## Agenda Item 11

<b>Report of the Head of Planning and Enforcement</b>
Address:	M4 motorway, Junctions 3-12
Development:	Development Consent Order application under the Planning Act 2008 to the Planning Inspectorate by Highways England for the construction of a smart motorway on the M4, junctions 3-12 (application accompanied by an Environmental Impact Assessment)
LBH Ref Nos:	71068/APP/2015/2700

The M4 Junction 3 to 12 Smart motorway proposals

Local Impact Report

Area identified in red

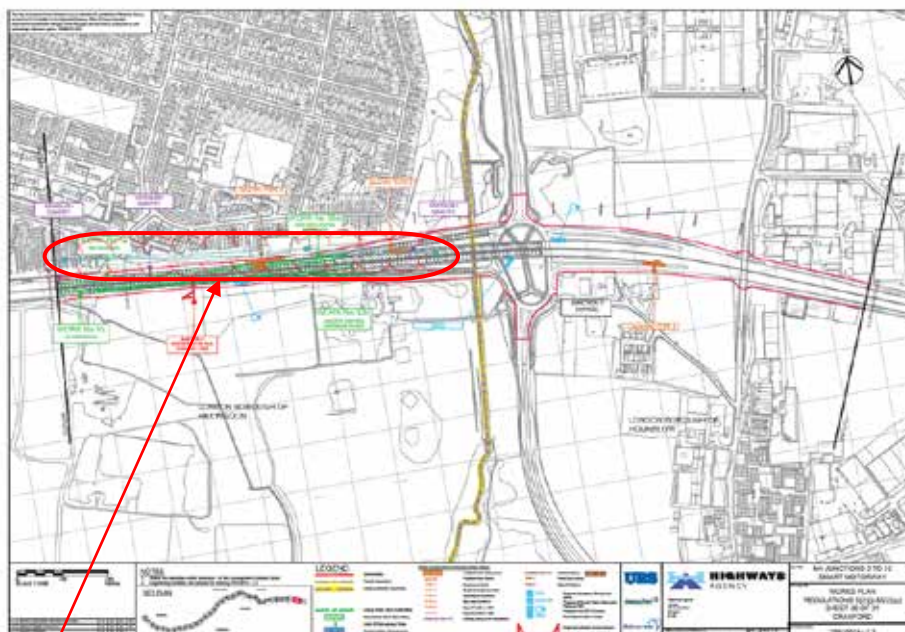
Document ref. TR010019, Vol.2.8 *Gantry General Arrangements*, illustrates the generic gantry details, including the Type 1 'Superspan Portal Gantry', Type 2 Single Span Portal Gantry', Type 3 'Superspan Cantilever Gantry', Type 4 'Sign Only Cantilever Gantry', Type 5A and 5B 'MS4 Single Gantry (Options A and B) and Type 6 'MS3 Signal Gantry'. The proposed locations of the gantries are indicated on the series of *Environmental Masterplans*, sheets 27-30, dwg ref.514451-MUH-ML-ZZ-DR-EM-300761, 300762, 300763 and 3000764. These structures will be lit and have a height and mass above the carriageway which will be difficult, or impossible, to screen from views beyond the motorway corridor. They will be particularly visually intrusive in the landscape when viewed from public spaces and residential properties lining the route. (Vulnerable residential areas include, from east-west, Cranford Drive, Moston Close, Cleave Avenue, Savoy Avenue, Arlington Close, Vine

Close, Keats Way, Wordsworth Way, The Brambles, Little Benty and Verbena Close.). A plan of some of these areas referred to above is provided below and a request has been made that this area is visited as part of the site visit itinerary:

The applicant should provide clearer information on the extent of vegetation lost, the interim proposals, and detailed long term plans. There is likely to be a significant time delay of some years between vegetation being removed and new planting maturing. It cannot be said therefore that a like for like landscaping plan results in no net loss. The applicant should consider offsite improvements. Adequate landscaping re-provision is essential as part of the proposed works and should be agreed in consultation with the council prior to the determination of the DCO.
